Hotwire™ DSLAM for 8000 MCC and 8546 DSL Cards Firmware Update Description, Release 2.03.15

Document Number 8000-A2-GK54-00

December 1998

DSL Performance Stats

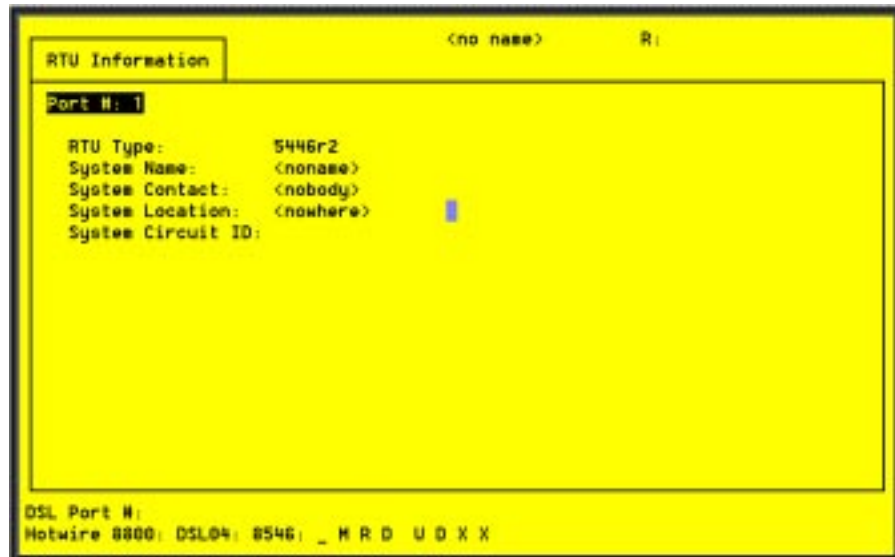
Two fields have been added to this screen under **Customer Data**:

- **k octs sent dn** – Displays the number of octets (in thousands) of customer data sent by the DSL card to the endpoint.
- **k octs rcv up** – Displays the number of octets (in thousands) of customer data received by the DSL card from the endpoint.
